# Access Compliance Report

## Public Rights-of-Way

### (Curb Ramps)

Intersection ID: 21396	Main Street: W_ARROWOOD_RD	Cross Street: FOREST_PINE_DR	Location: SW
ADA ID: 697C1B267C77	Ramp Type: Combination2Diag	Initial Pass/Fail: Fail	Overall Compliance: No
		Severity Score: 0

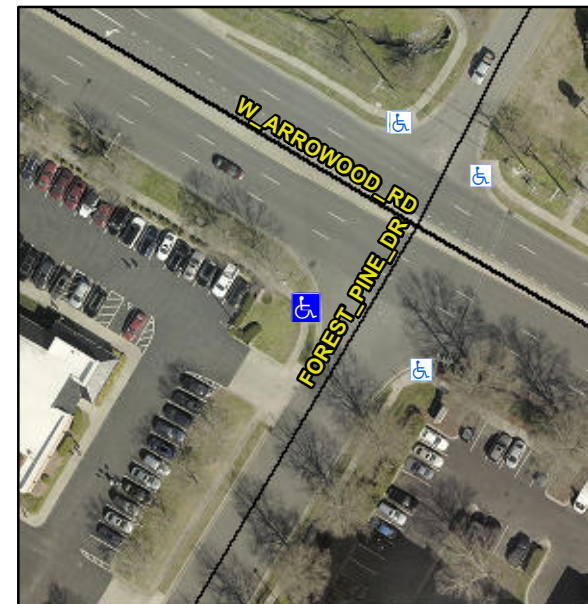
**MEDIAN ACROSS W ARROWOOD RD**

**R304.5.1, R304.5.3**

**Remove & Replace Curb Ramp With Two New Directional Ramps or Equivalent.**
